Your Ref
BN/13/15/PL
Our Ref
PLAN-010371
Date
10/07/2015

Proposal: Demolition of existing shed/garage & erection of 1 No. detached dwelling.

Site: Saxons 33 Hill Lane, Barnham, PO22 0BL, BN/13/15/PL

Southern Water MapGuide Browser

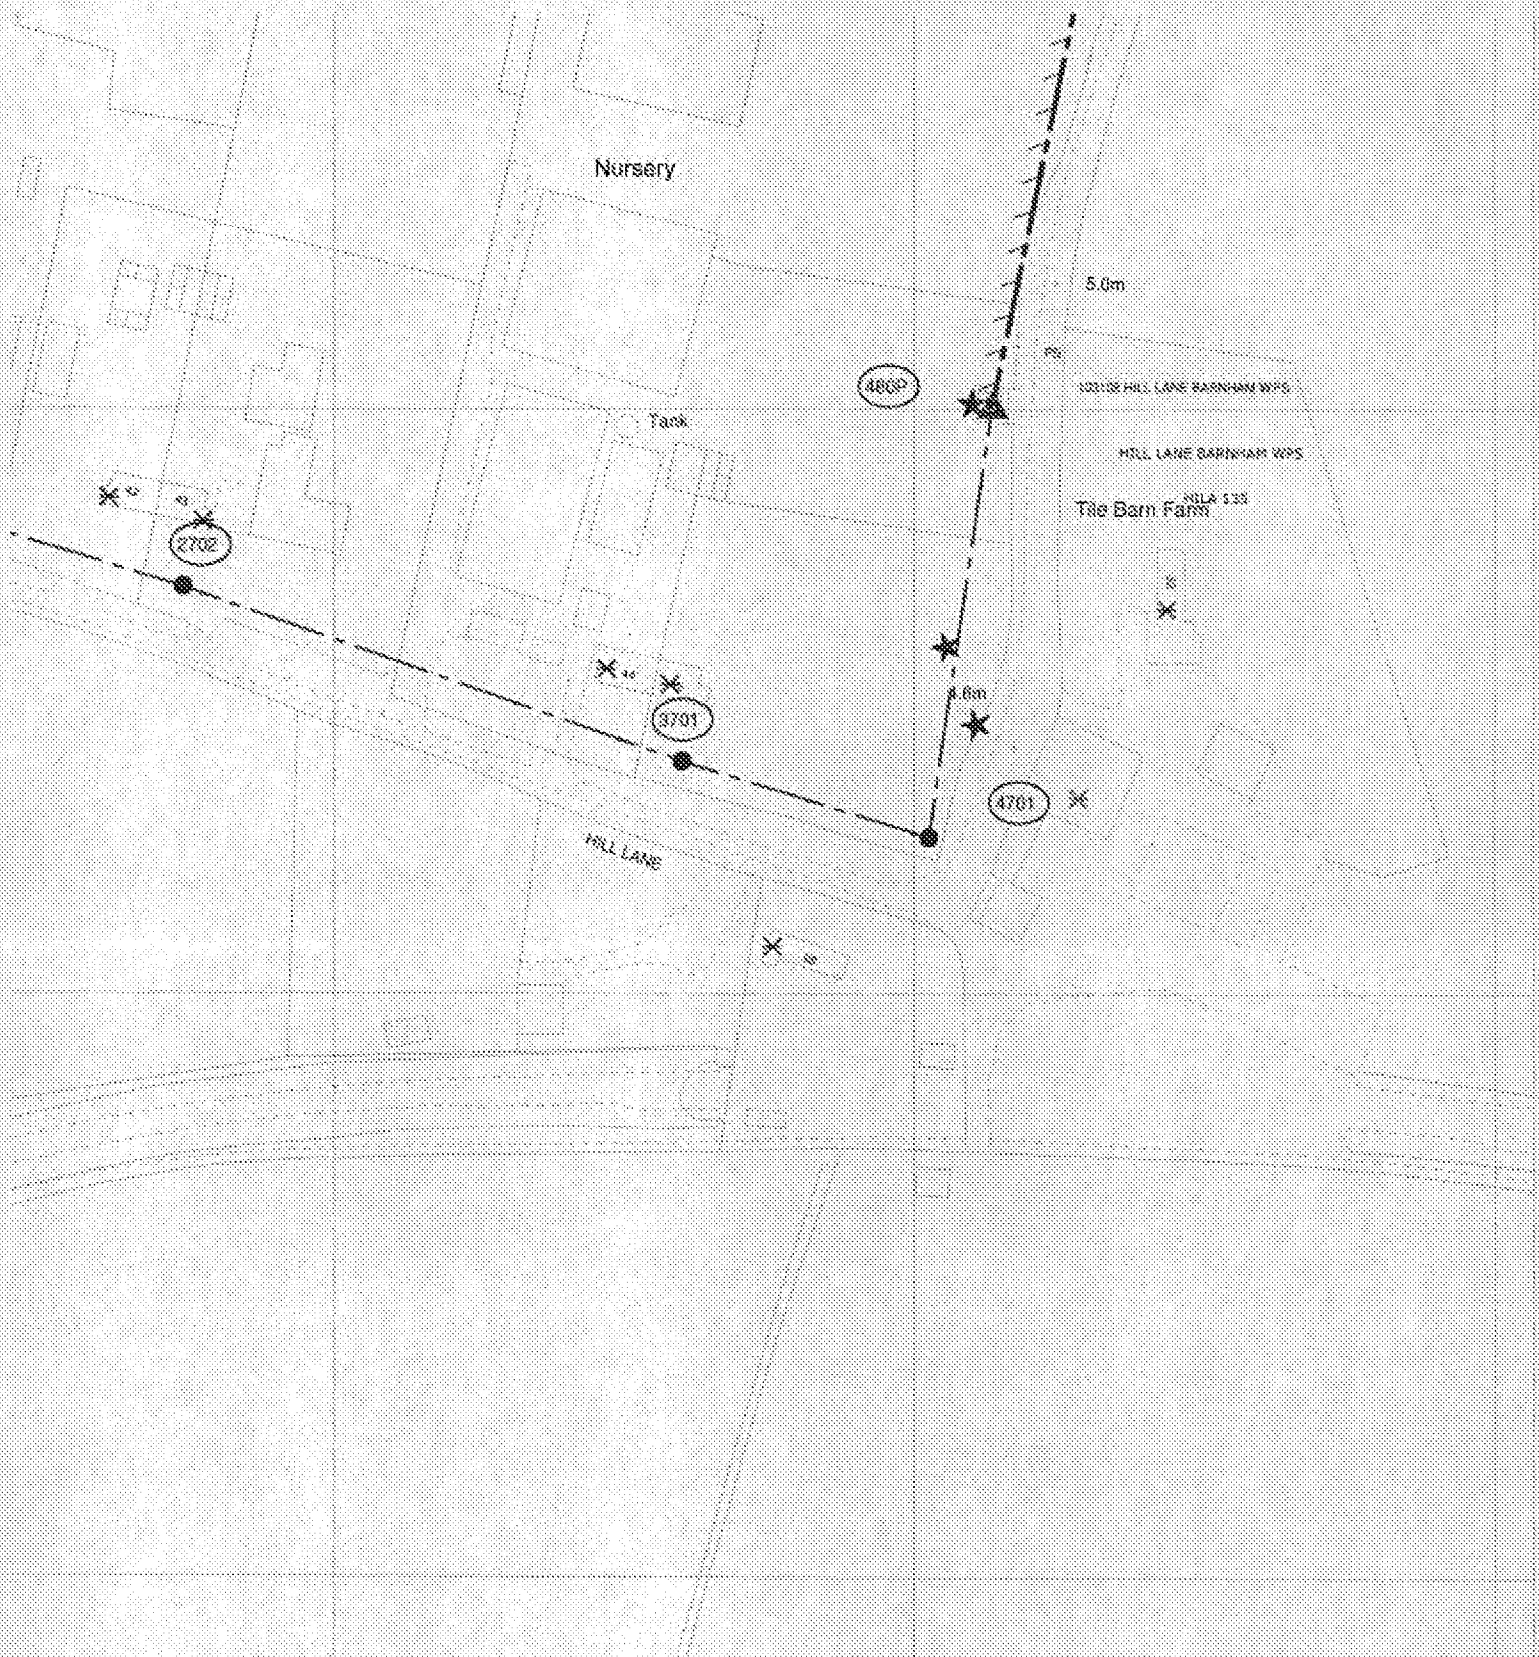
Due to changes in legislation that came in to force on 1st October 2011 regarding the future ownership of sewers it is possible that a sewer now deemed to be public could be crossing the above property. Therefore, should any sewer be found during construction works, an investigation of the sewer will be required to ascertain its condition, the number of properties served, and potential means of access before any further works commence on site. The applicant is advised to discuss the matter further with Southern Water, Sparrowgrove House, Sparrowgrove, Otterbourne, Hampshire SO21 2SW (Tel: 0330 303 0119) or www.southernwater.co.uk.

WARNING: RAC pipes are constructed of Bonded Asbestos Cement

WARNING: Unknown (UNK) materials may include Bonded Asbestos Cement
